寄件者: Marine Aquaculture YSO [REDACTED]
寄件日期: 2024年09月24日星期二 10:33
收件者: Candice Yan Ki LO/PLAND
主旨: Planning Application A/NE-YSO/10 Additional information
附件: 20240924 Brief Site Map.pdf; 20240924 Additional information.pdf
類別: Internet Email

Application: A/NE-YSO/10 - additional information sheet

Yung Shue O Marine Aquaculture Association

Here is a screenshot of the measurement:

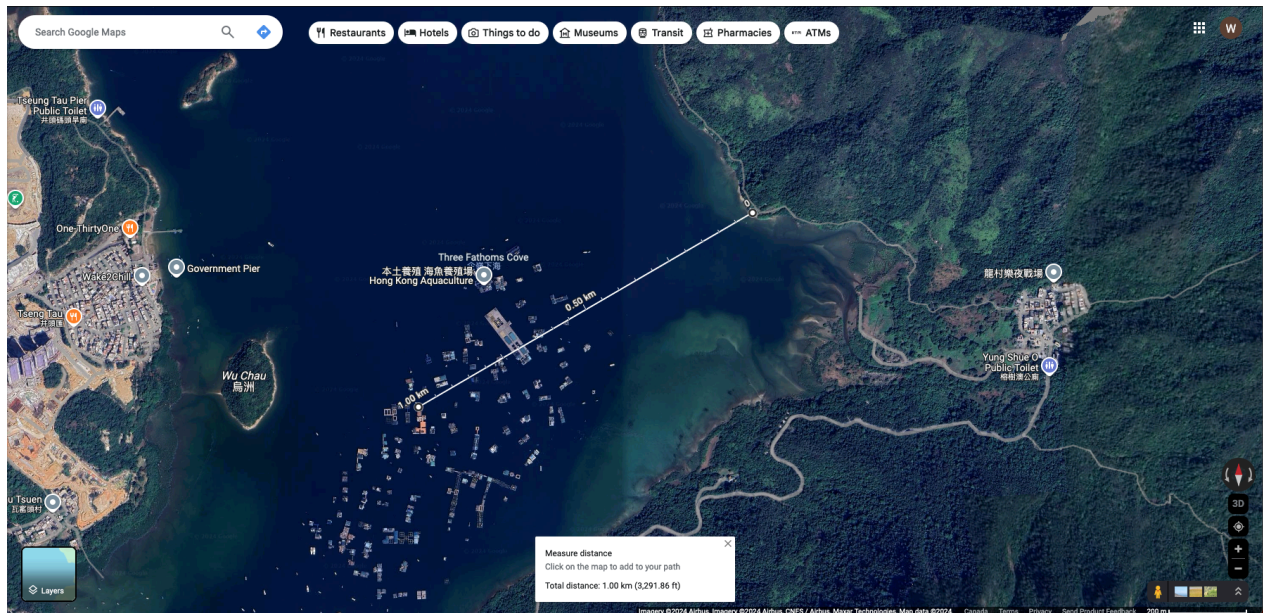
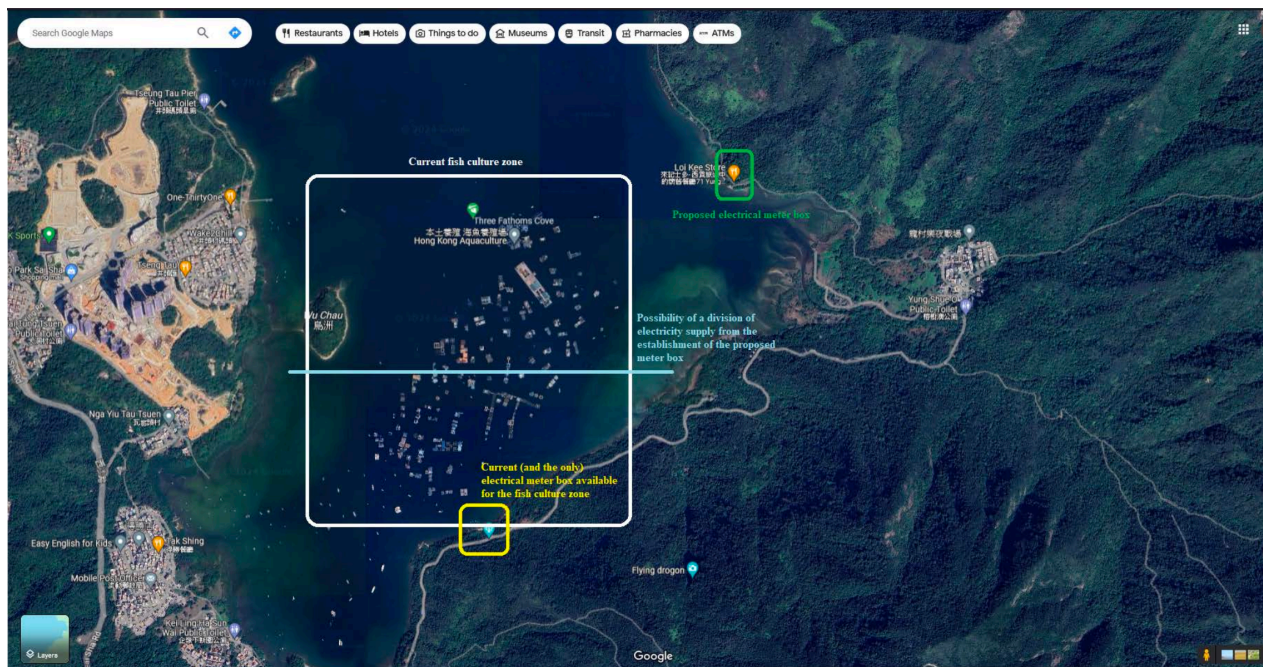
In practice, one main possibility is to directly connect the cables to the entire fish culture zone. We did the measurement on Google map for the cables to the northmost part of the fish culture zone, meaning that the cable will be about 750m in length when it reaches the northmost fish farm. We would like to add 5% in expectation as a buffer since the plotted fish farm is the northmost part, while this proposal is intended not only for one fish farm but the northern part of the zone. This will make it a maximum of 787.5m in length for the cable. Please check the screenshot below for the measurement:

However, there are also fish farms in the middle of the zone which may not be able to acquire adequate and stable supply of electricity. In consideration of these fish farms, we measured that the possible cabling plan towards the northwest of the zone is 1000m (rounded off) in length, with 5% added buffer it will be 1050m.

Conclusively, we would suggest that the expected length of the cable would range from 750m to 1050m.
